Addendum No. 1

RE: Contract # C205160

Forsyth County (Project BR-0168)

BRIDGE #330289 OVER US-52 ON SR-4000.

PHASE 1, STEP 3 (2)
DETAILS

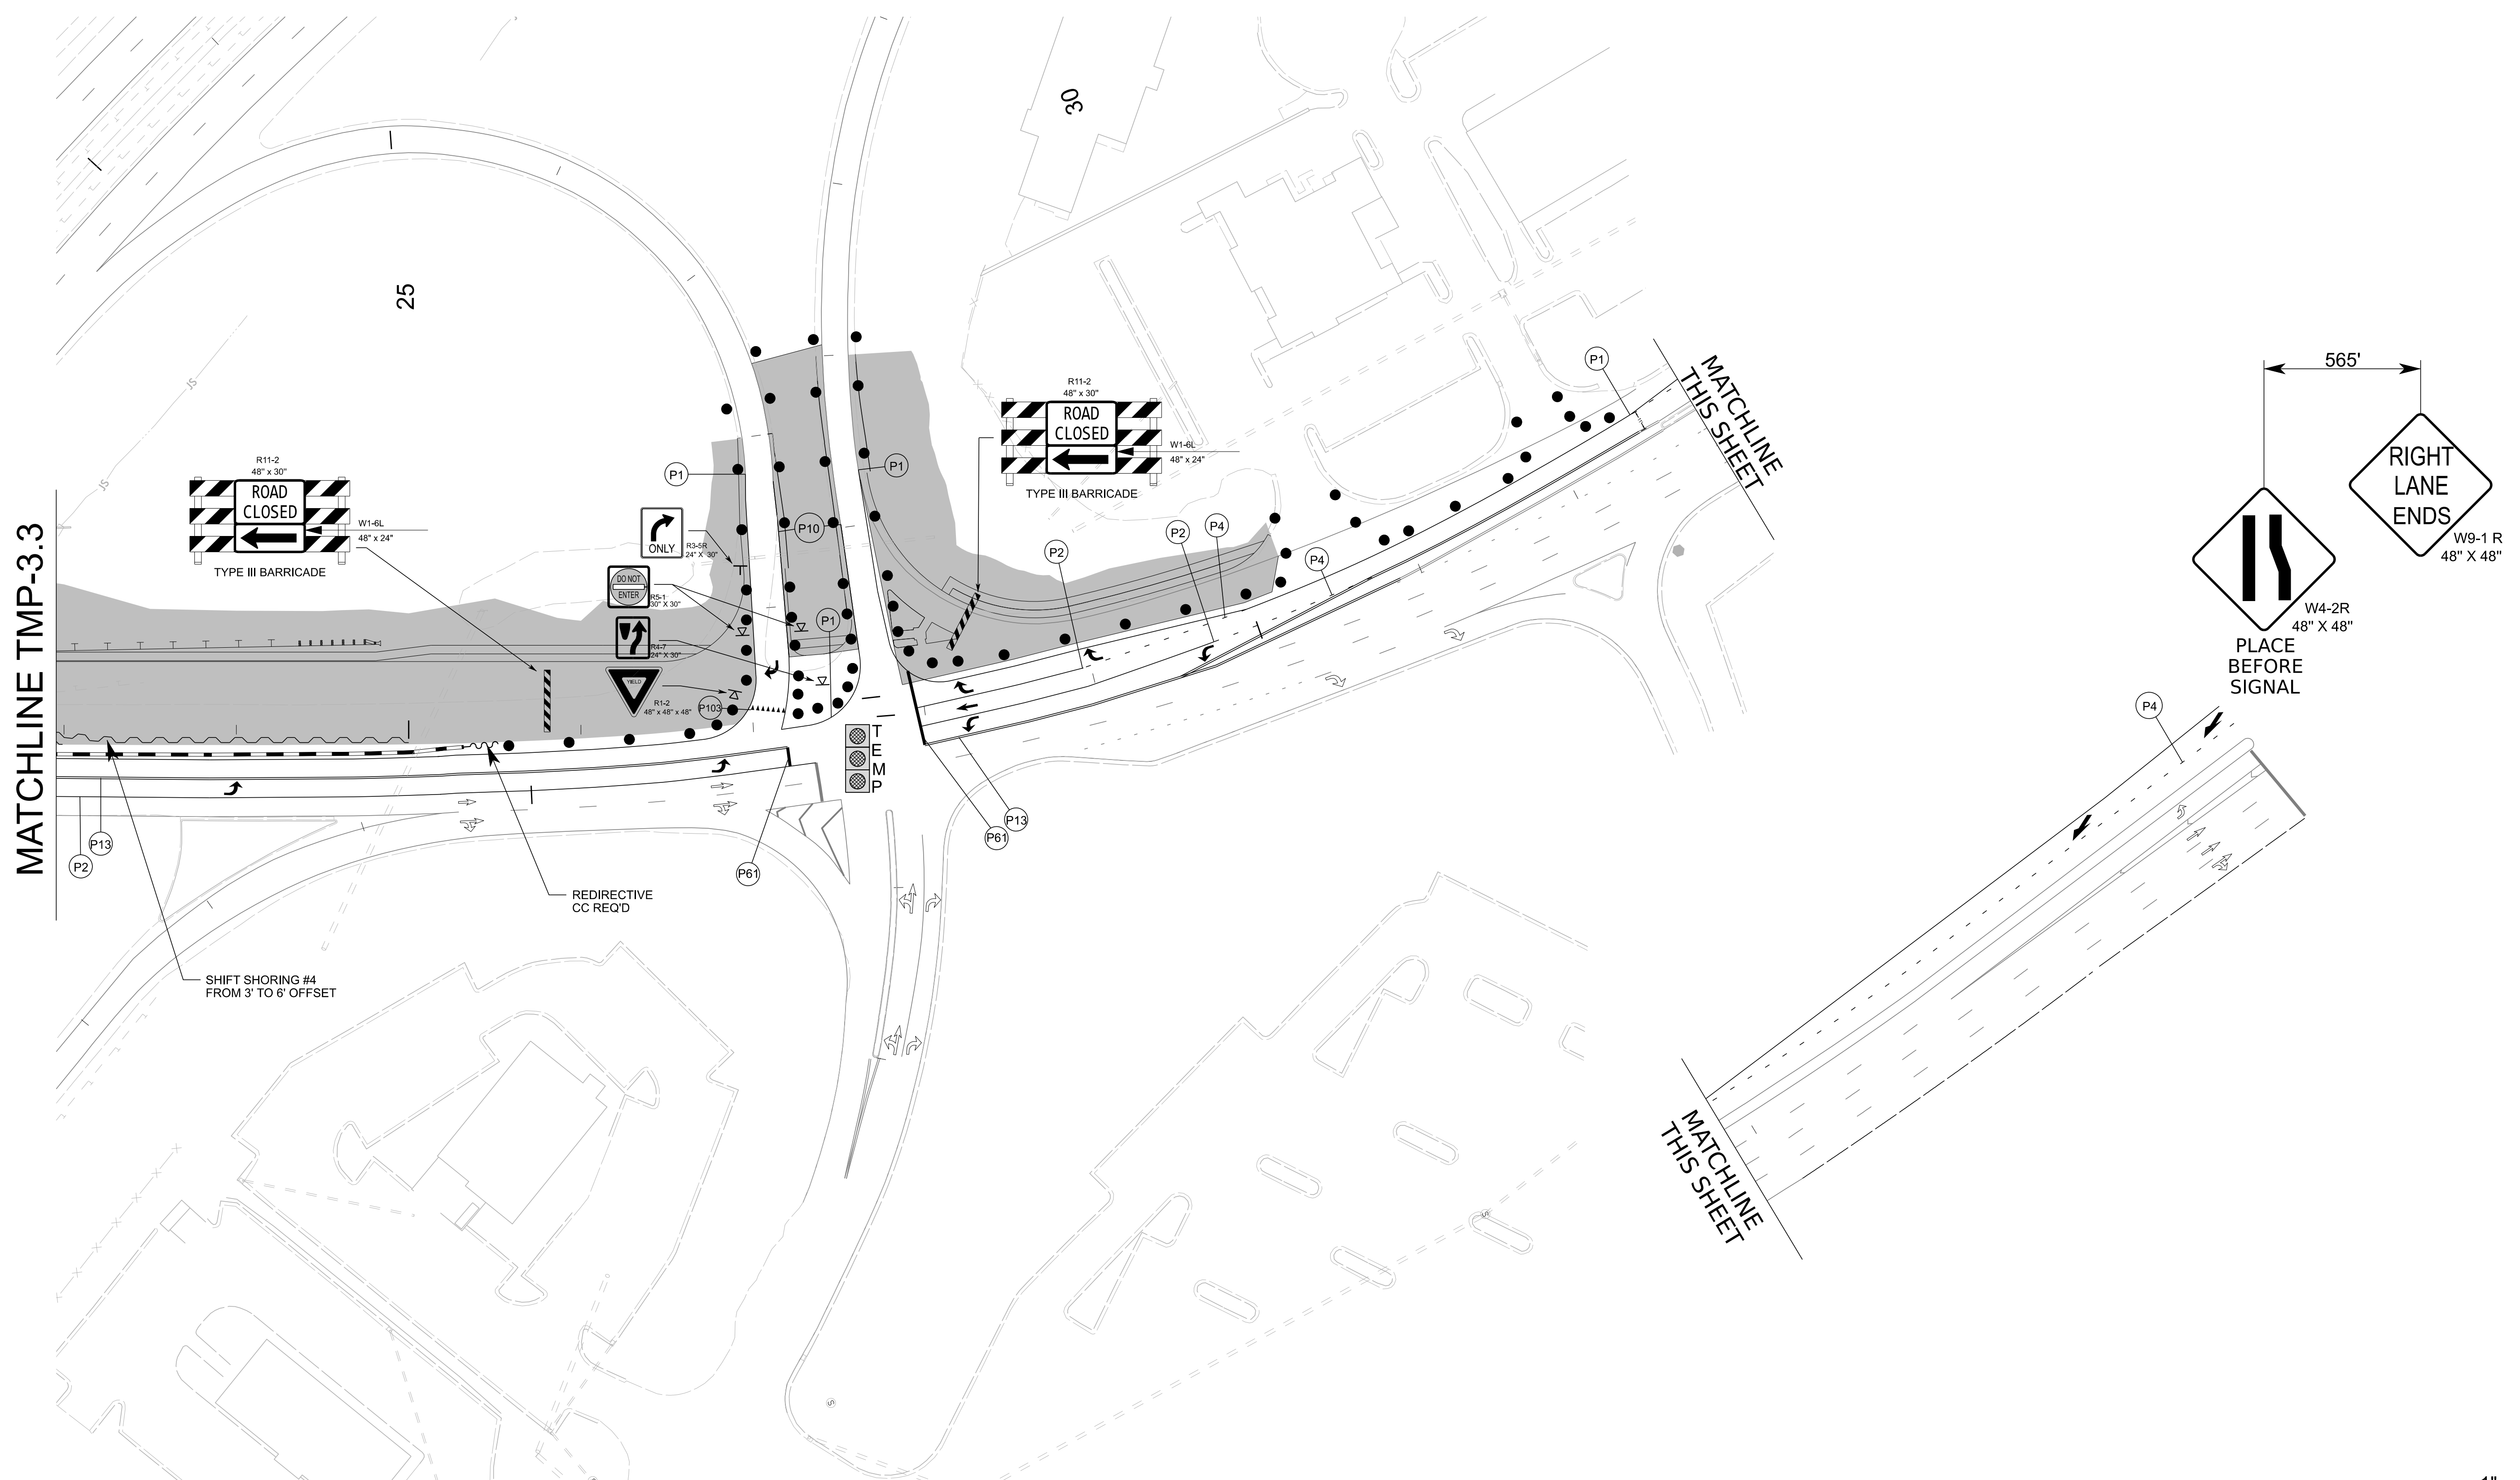
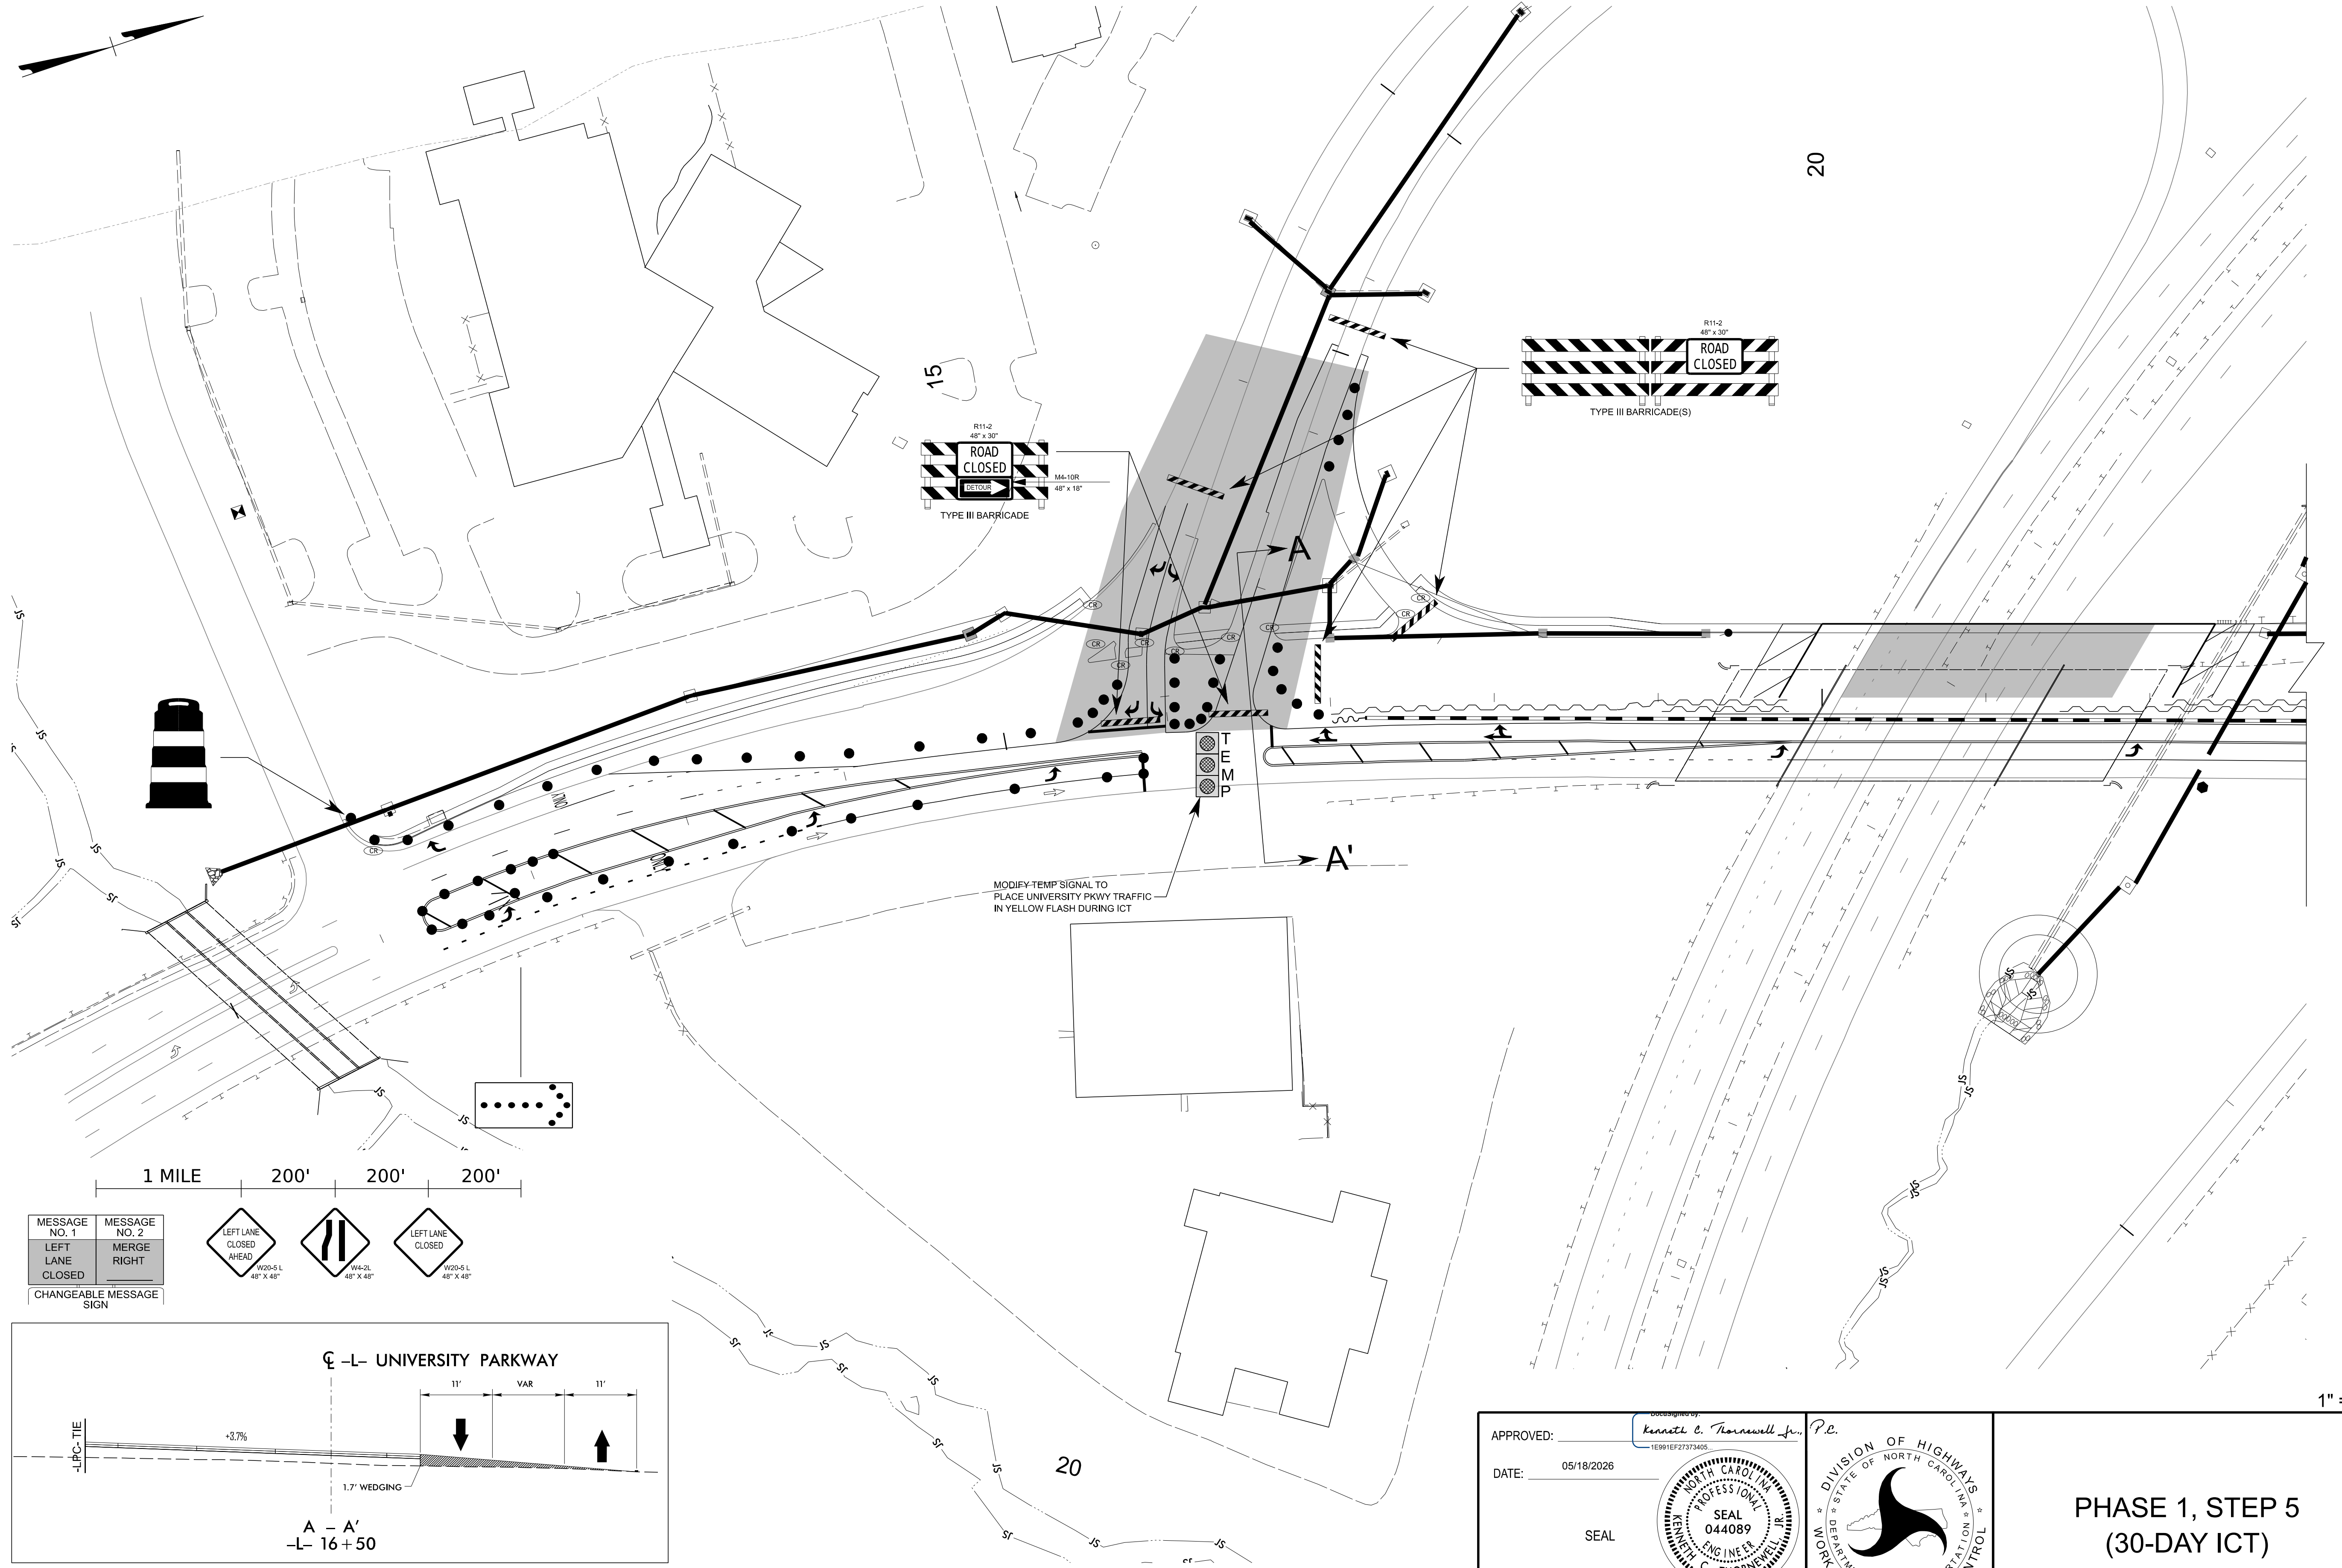
Sheet No.	Revision
TMP-3.4	Replaced with new sheet
TMP-3.5	Title block revised – match line corrected
TMP 3.6	Title block revised – match line corrected
